Access Compliance Report Public Rights-of-Way (Curb Ramps)

Main Street: RANCHWOOD_RD Cross Street: IRVINE_BLV Location: NW

ADA ID: RPRK220103125558 Ramp Type: Type 1 - Perpendicular Diagonal Initial Pass/Fail: Pass Overall Compliance: No Severity Score: 15

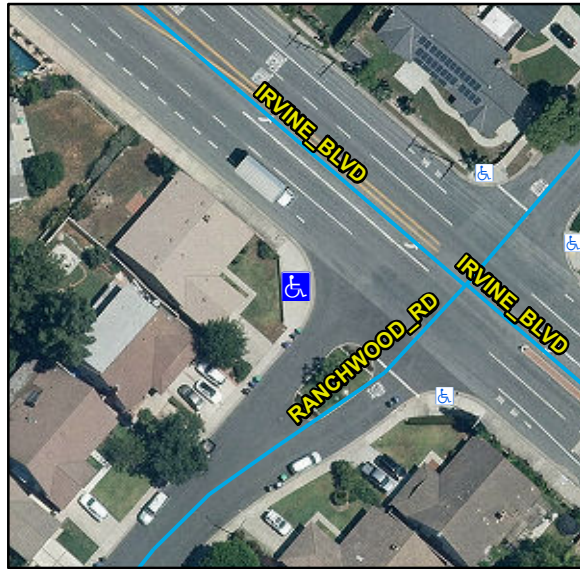
N/A	Ramp Inside Crosswalk 1	N/A	Yes	Ramp Inside Crosswalk 2	N/A
	Crossing 1 Slope (%)	3		Crossing 2 Slope (%)	7.5
	Crossing 1 Cross Slope (%)	0.2		Crossing 2 Cross Slope (%)	1.8
Yes	Gutter Ponding	No	Yes	Curb Slope	3.8
Yes	Gutter Lip Height (in)	0		Road Run Slope (%)	1
No	Gutter Run Slope (%)	8.3		Road Cross Slope (%)	2.1
Yes	Gutter Cross Slope (%)	0.5			
Yes	Overall Surface Condition: Acceptable		Yes	Perp Joint Present	Yes
	Cross Gutter Present?	No		Spandrel Present?	No
	Replace Cross Gutter?	N/A		Replace Spandrel?	N/A

Install Detectable Warning System. Remove & Replace Gutter.
